2.1.6 Responses to Comments from Organizations and Companies

OC1 - Save the Sound

200701235058 Received FERC OSEC 01/23/2007 03:59:00 PM Docket# CP06-54-000, ET AL.

Figure 3. Projected increase in natural gas demand in New York and Connecticut through 2012, compared to estimated 2012 potential savings from cost-effective electric and gas demand management programs relative to business as usual.

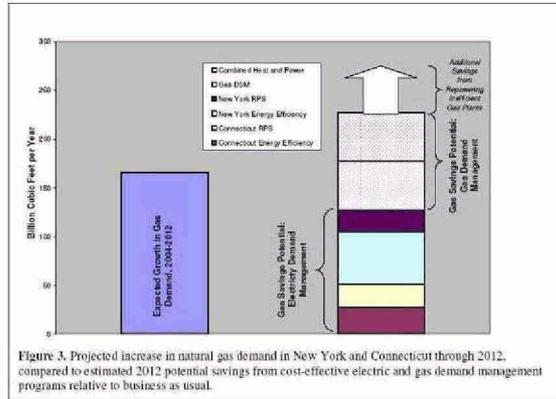
In the 2007 update, Synapse found that the federal government forecast for gas demand over the next two decades has been revised significantly downward relative to previously available forecasts.³¹ Referencing the Connecticut’s Energy Independence Act that requires electricity suppliers and distribution companies to acquire 4% of their supply from combined heat and power implementation of commercial/industrial energy efficiency by 2010 and the expanded use of demand management in Southwest Connecticut, Synapse also found that the 2006 report may have been conservative in estimating the future role of efficiency and renewables in meeting the region’s energy needs.³² These programs are among the most cost-effective ways for the states to meet growing demand, to accomplish climate change emission reduction goals and to reduce energy bills.³³

⁵⁴ See Synapse Energy Report, *supra* note 26. The attached graph, *Project U.S. Demand for Electricity Generation*, details an example of such changes.

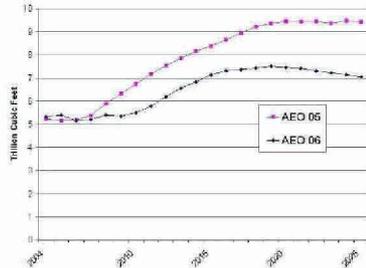
At that time it was still expected that a lot of new gas generation was going to be built around the country but that is no longer the case. This is reflected in the AEO reports, which as of 2005 showed approximately 9.5 tcf of gas per year for electricity generation by 2025, but in 2006 showed just over 7 tcf per year (see Figure 1 EIA Forecasts of Natural Gas Usage by Electric Power Sector in AEO 2005--which was used in the DEIS--and 2006). EIA now predicts national natural gas usage by electric generators will decrease slightly over the next few years, returning to 2005 consumption level by 2010.

OC1-40 Please see our response to comment OC1-33.
